TO:	CHAIR AND MEMBERS BUILT AND NATURAL ENVIRONMENT COMMITTEE
FROM:	D. N. STANLAKE DIRECTOR DEVELOPMENT PLANNING
SUBJECT:	APPLICATION BY: MARIO GARCIA 495 OAKRIDGE DRIVE PUBLIC PARTICIPATION MEETING ON OCTOBER 17, 2011 AT 5:15 PM

Date Application Accepted: July 19, 2011	Agent: Development Engineering Limited
REQUESTED ACTION: Conduct a public meeting on behalf of the appointed officers with regard for approval of Site Plan with 7 cluster single detached dwellings at 495 Oakridge Drive.

OAKRIDGE HEIGHTS
 495 OAKRIDGE DR. LONDON, ONTARIO, N6H 2V5
 7 SINGLE DETACHED HOMES - CONDO CORP.
 CON 3 PT LOT 21 PLAN 784
 PT LOT 5 AND 10 3/41/07 PARTS 1 AND 2

SHEET NUMBER:
A - 100

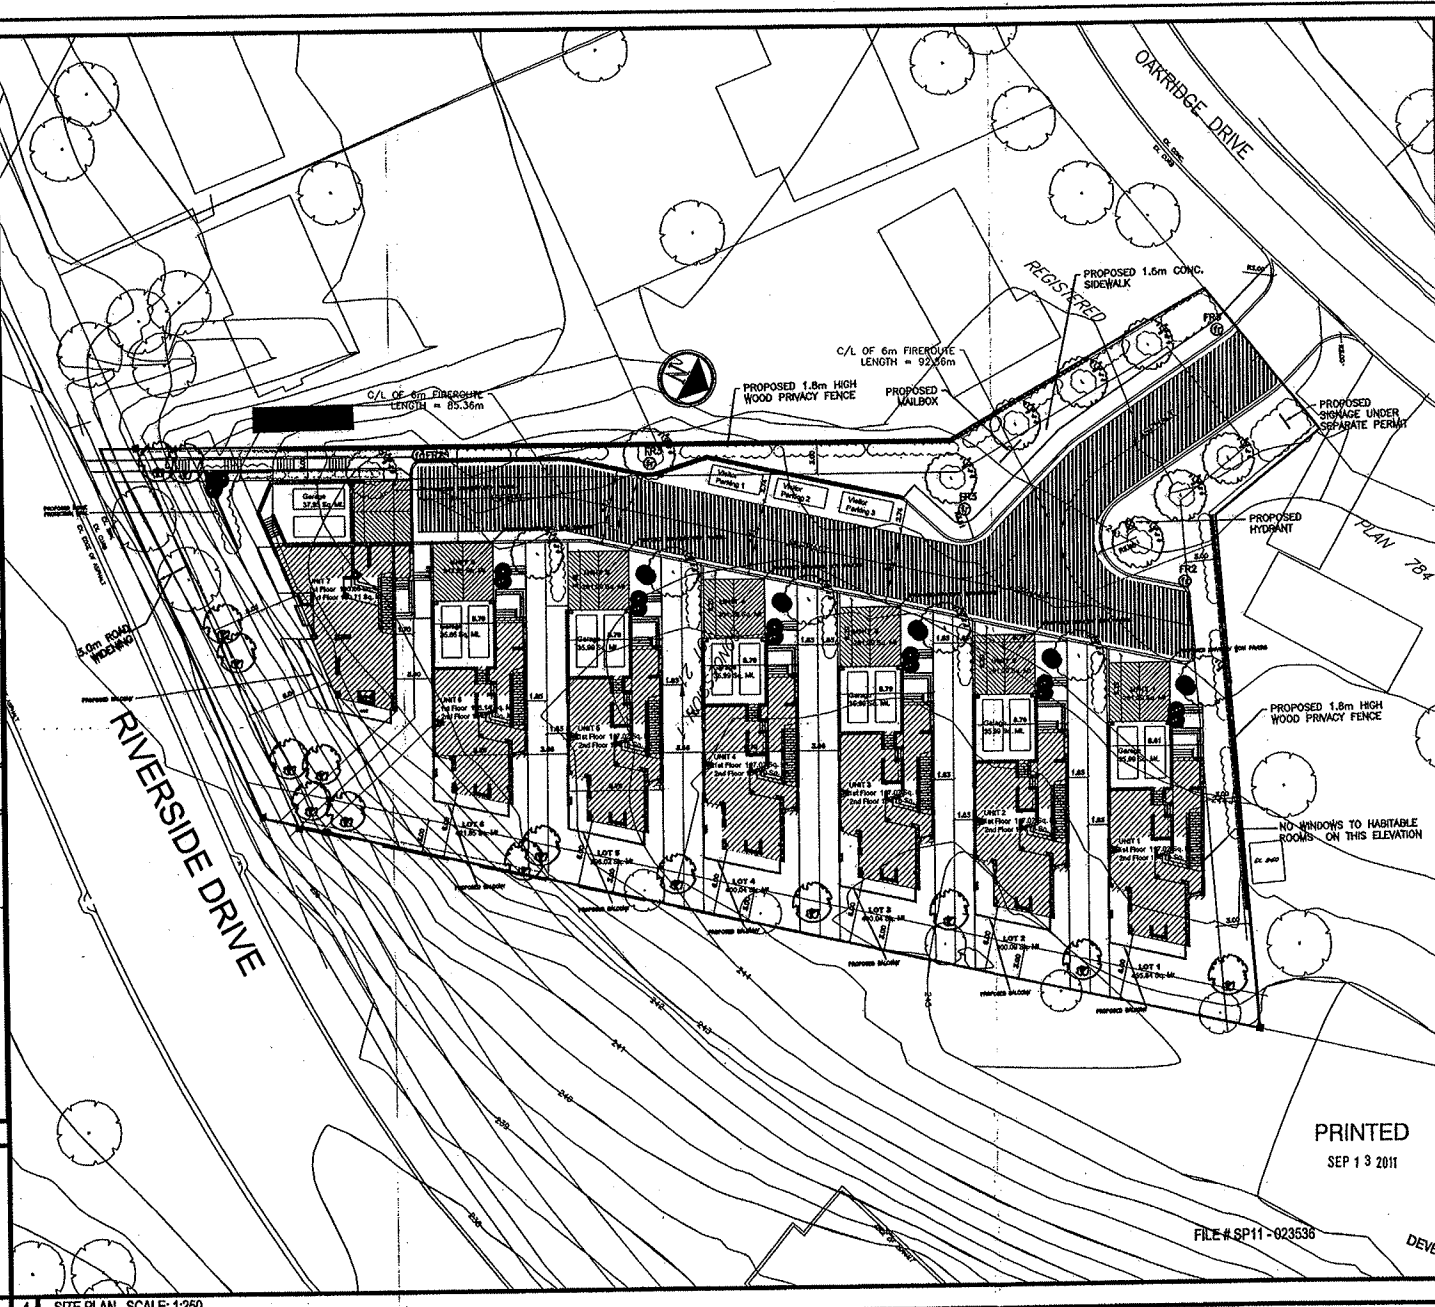
1. *Reorient the south unit facing Riverside Drive to align with Riverside Drive;*
2. *Make a larger statement with the Riverside Drive unit by reworking the plan and elevation – consider taking advantage of the major grade change along Riverside Drive;*

8. *Eliminate fence extensions at project entrance to Oakridge Drive. Consider definition of entrance with fencing/gates in line with Oakridge Drive building plane;*

9. *Consider shortening the walking distance to the nearest public transit route stops by adding a pedestrian link west of the southerly unit facing Riverside Drive to connect the development to Riverside Drive;*

10. *Enhance landscaping to buffer project from neighbouring residence; and*
11. *Utilize pervious materials such as pervious poured-in-place concrete or pavers to the development's driveways to facilitate on-site retention of storm water.*

The majority of items 7 - 11 have been addressed as the fence extensions have been eliminated from the project entrance to Oakridge Drive, there is a pedestrian connection to the development from Riverside Drive, enhanced landscaping and privacy fencing will buffer the site from the neighbouring residences, and pervious pavers are utilized for the driveways.

SHEET NUMBER:
A - 201

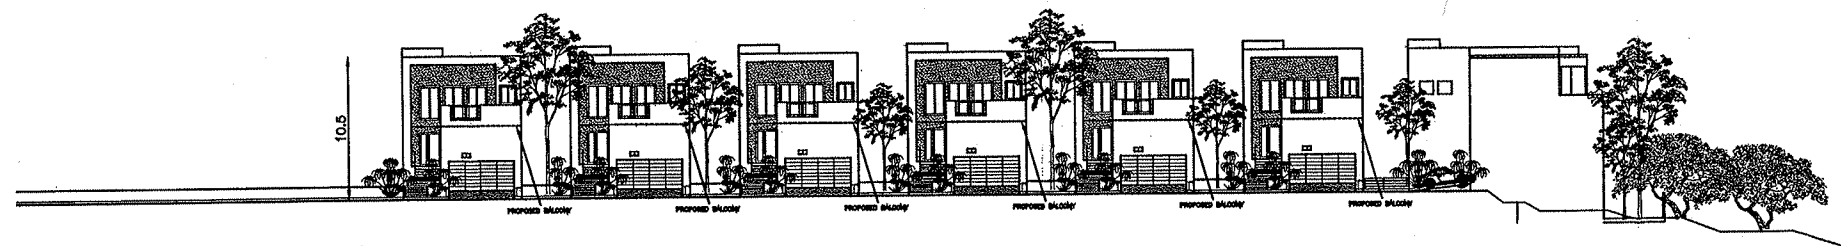
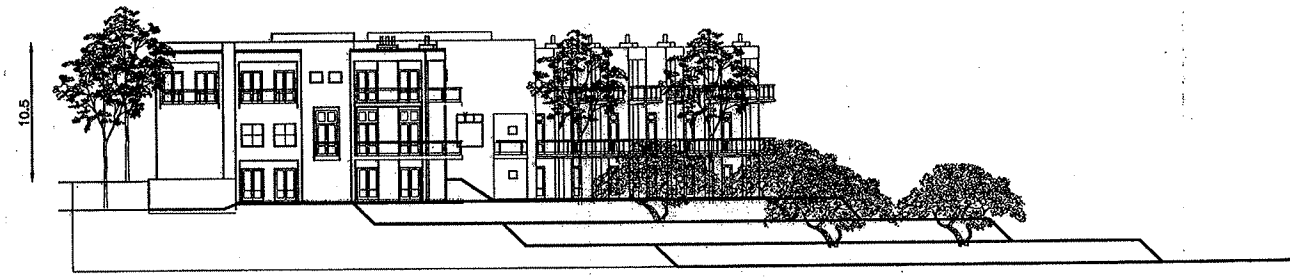
3. *Add openings to the balcony walls of the south eastern units to enhance views of the river;*
4. *Rework south western elevations to improve security and safety of the pedestrian realm along the internal street by enlarging windows;*

5. *Consider adding balconies to the internal street elevations to reduce impact of garage roofs and/or revise garage roofs by adding green roofs;*
6. *Enhance overall design standard of unit elevations by differentiating materials, adding additional detail and/or introducing masonry units;*

Items 1-6, have been addressed as the owner has made alteration to the elevation to the satisfaction of staff in Urban Design.

September 20, 2011 the revised Elevations were stamped accepted for Urban Design by Eno Rebecca Udoh-Orok the Urban Designer.
